GARDEN 1 (GR) |ELEVATION 1. 2 & 3|

TITLE SHEE

BARLASSINA CONSTRUCTION CITY OF CAMBRIDGE

CITY OF CAMBRIDGE **BUILDING DIVISION**

GARDEN 1 FRONT ELEVATION 1

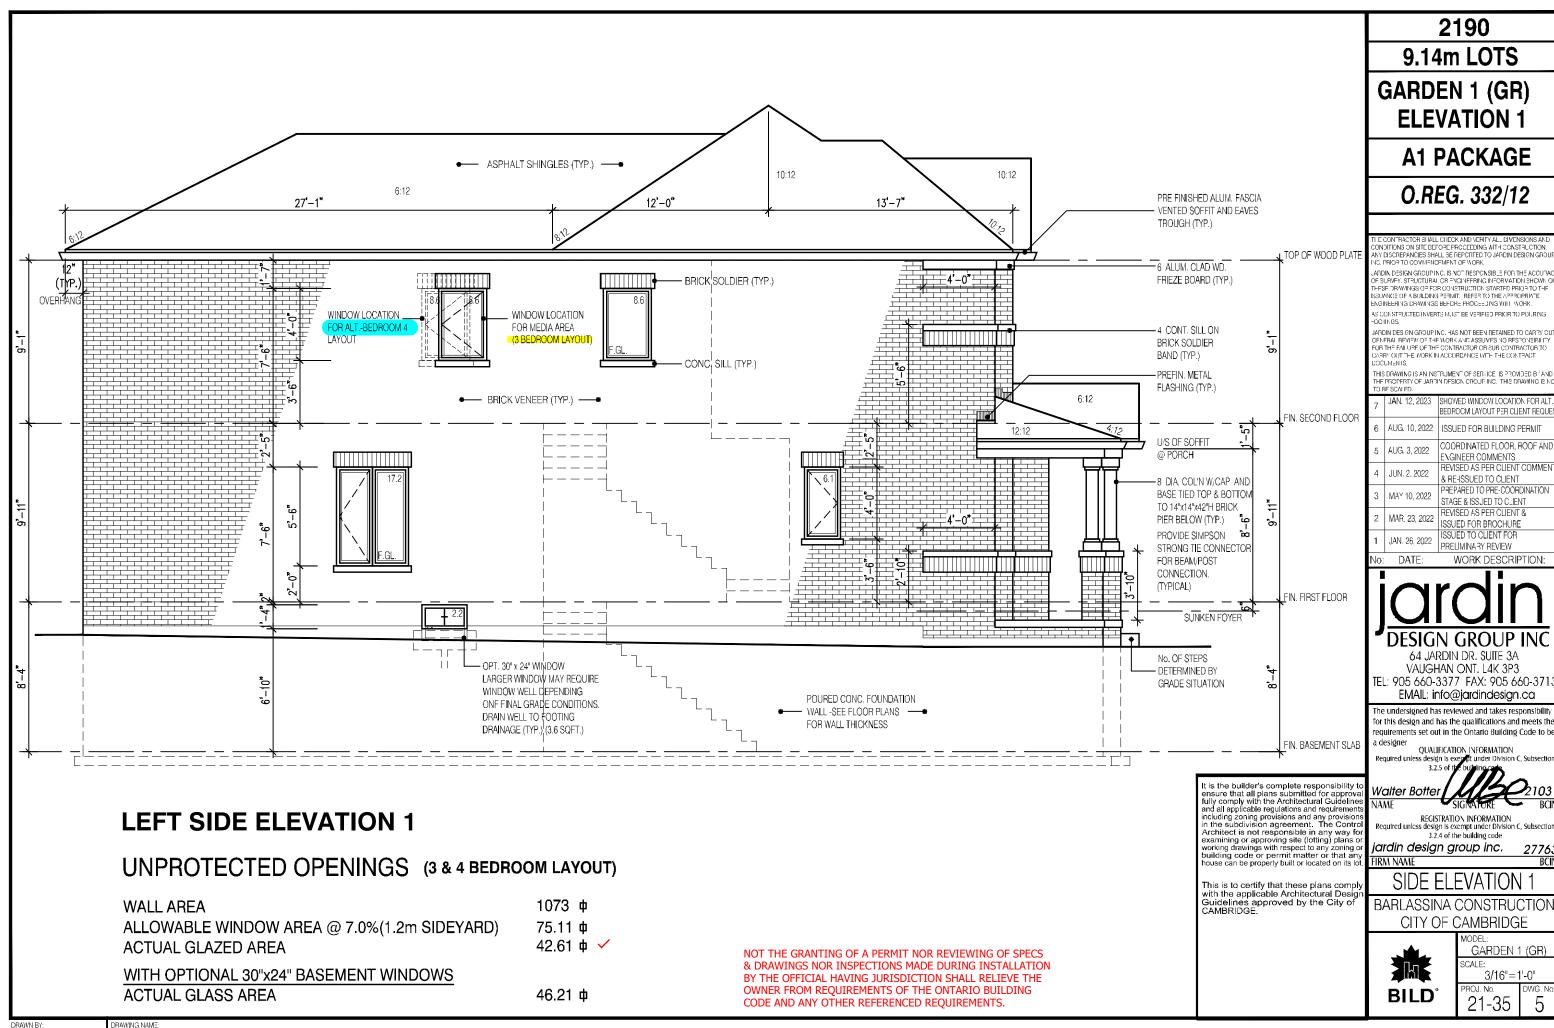
A LIGHT IS REQUIRED AT ALL ENTRANCES TO A SINGLE FAMILY DWELLING

GUARDS CONFORMING TO O.B.C. 9.8.8. & SB-7 ARE REQUIRED FOR PORCHES EXCEEDING 24" ABOVE GRADE.

ENSURE P.ENG STAMPED RAILING DOCUMENTATION AND ATTACHMENT DETAILS ARE AVAILABLE FOR REVIEW BY THE INSPECTOR

EXTERIOR CONCRETE STAIRS w/ MORE THAN 2 RISERS TO MEET THE REQUIREMENTS OF 9.8.9.2.(1)

REAR ELEVATION 1 DECK CONDITION

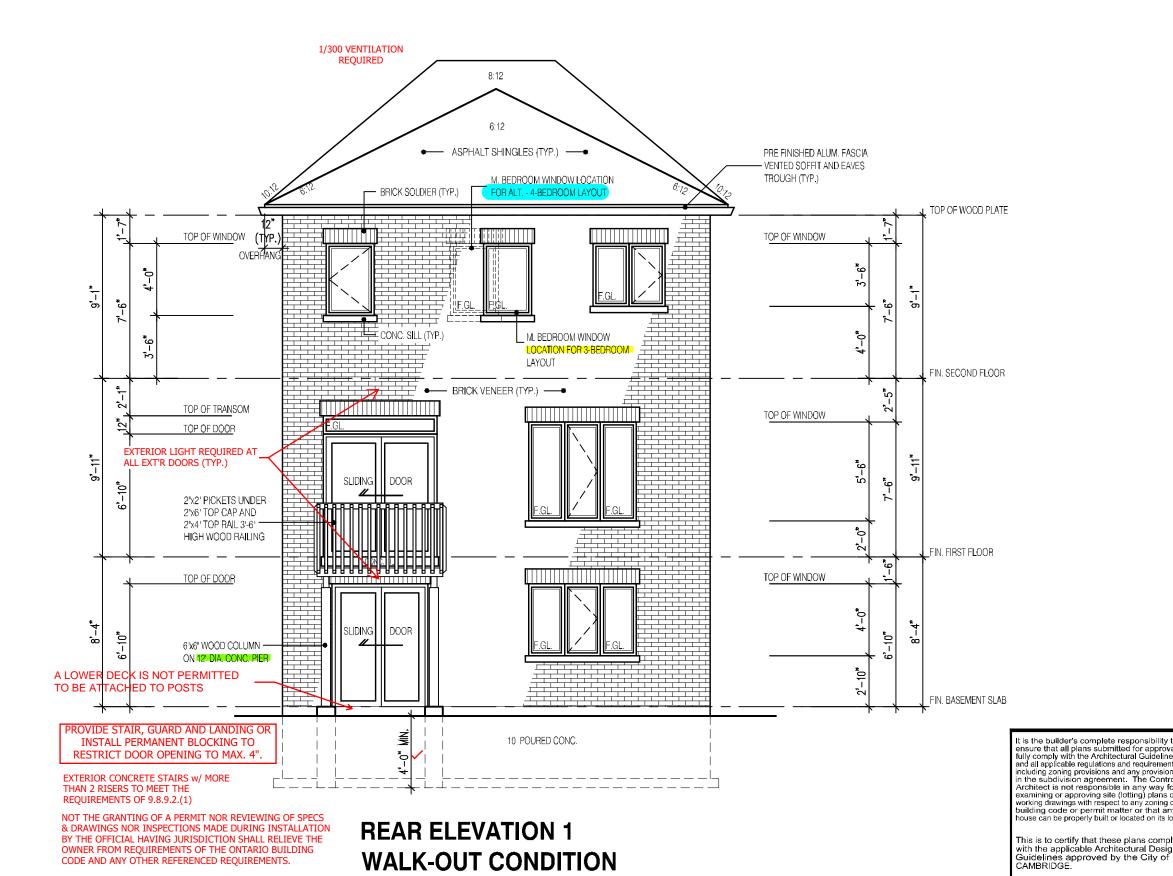
RESTRICT DOOR OPENING TO MAX. 4".

EXTERIOR CONCRETE STAIRS w/ MORE

THAN 2 RISERS TO MEET THE

REQUIREMENTS OF 9.8.9.2.(1)

FOR ADDITIONAL DECK STRUCTURE
REFER TO PAGE 7 OF THE DETAIL PACKAGE
